Monthly Specification Update

Intel® Workstation Board S5520SC

Intel Order Number E68106-021

May, 2011

28. Wrong Fan Fault LED may glow if "other chassis" is selected when flashing FRUSDR21

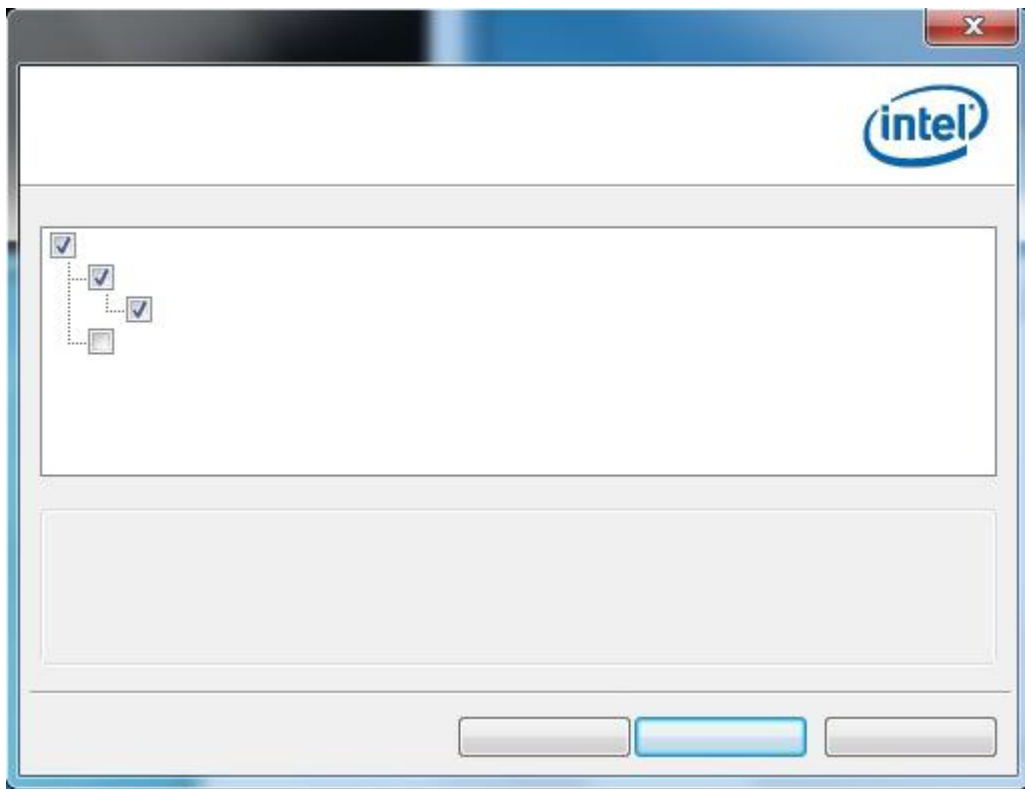
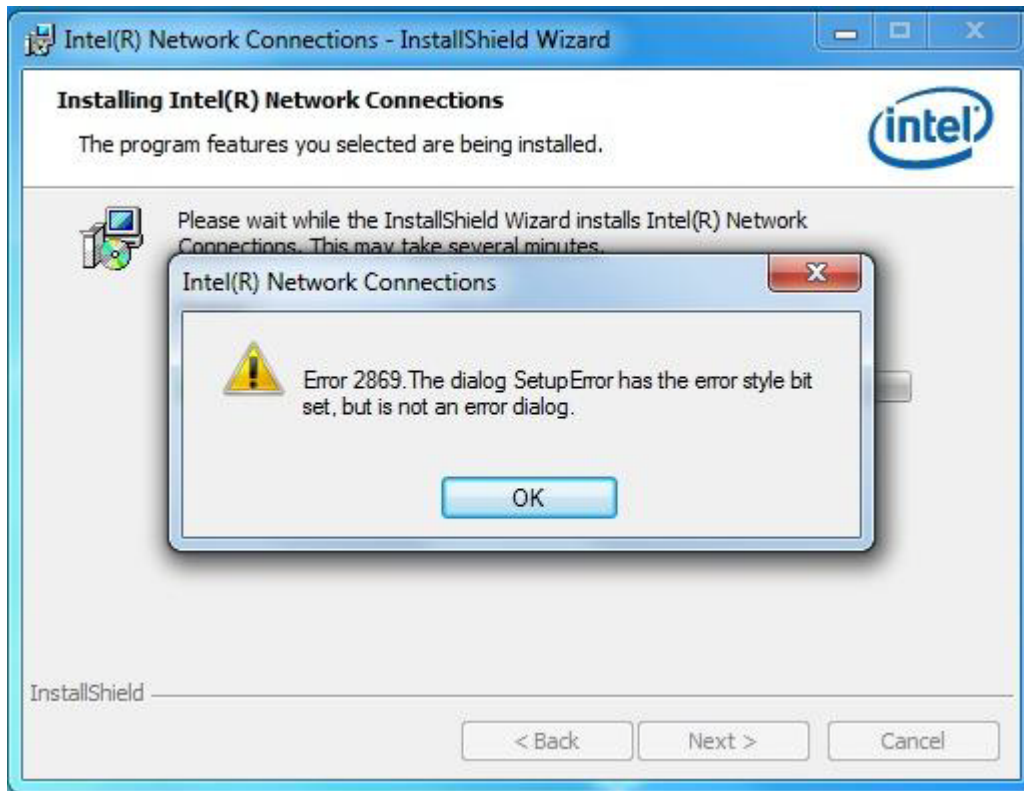
Problem When users update FRUSDR21 and select "other chassis" in the update process, users may see CPU FAN2 Fault LED glow when the upgrade process finishes. This issue occurs only when one CPU is installed in the motherboard.

Implication The unexpected CPU FAN2 Fault LED glowing event is due to a FRUSDR issue, however, there will be no functional impact to the system.

Status This issue is fixed by FRUSDR25.

30. NIC driver 15.1.1 may not be installed properly in Microsoft Windows Vista* or Microsoft Windows 7*

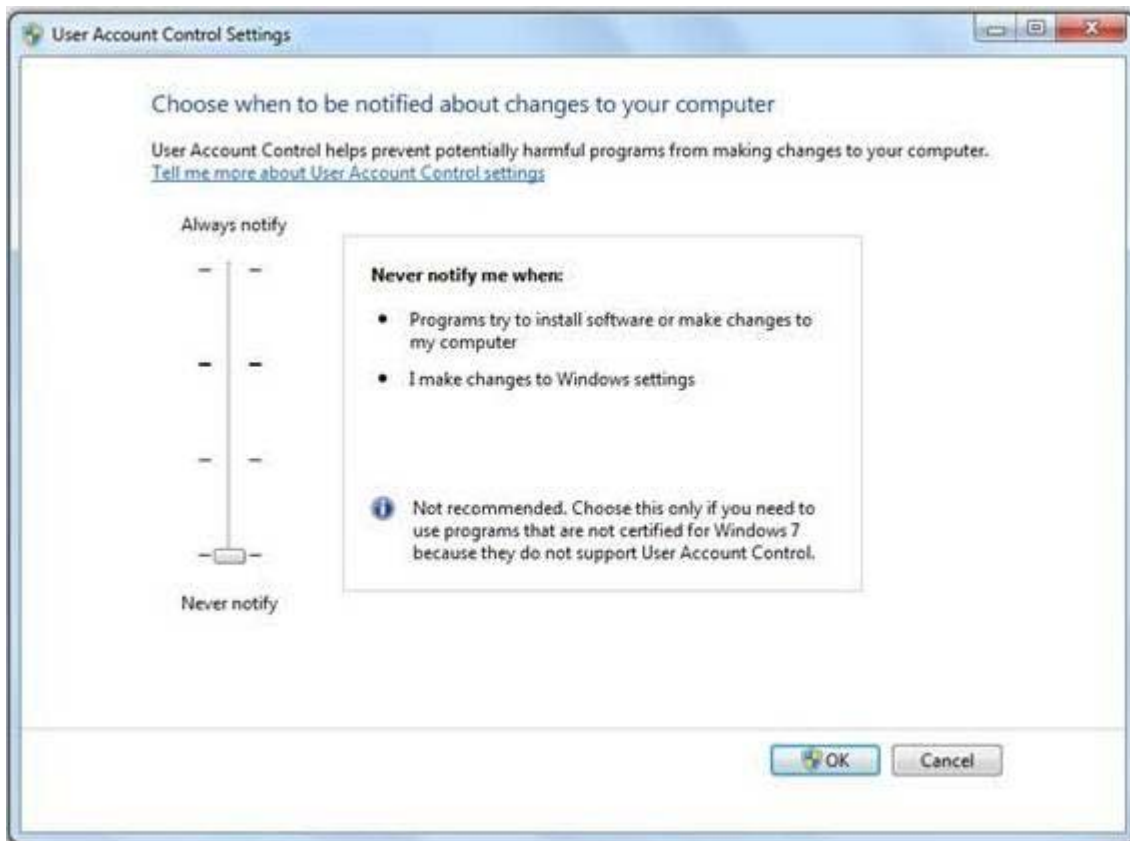
Problem	Users may find onboard NIC (Network Interface Card) driver version 15.1.1 may not get installed properly in Microsoft Windows Vista* or Microsoft Windows 7* when UAC (User Access Control) is set as "Default". Problem may occur during the installation process of the NIC driver, scramble display and unexpected message may display as following:
---------	---

- Implication** This is a permissions issue with Microsoft Windows Vista* and later operating systems. Permissions don't get elevated installing with PROSETDX.MSI, which is the file the batch file in the root directory points to. DXsetup gets the permissions elevated on Microsoft Windows Vista* and later operating systems, but they don't get elevated if you launch the MSI without DXsetup.
- Status** This issue will be fixed by future NIC driver release.
- Workaround** The following workaround can be used to navigate around the issue.
1. Users can browse to the \apps\prosetdx\ - 2. Users can also refer to below picture to set Windows UAC (User Account Control) to "Never notify", re-install the driver after a system reboot.
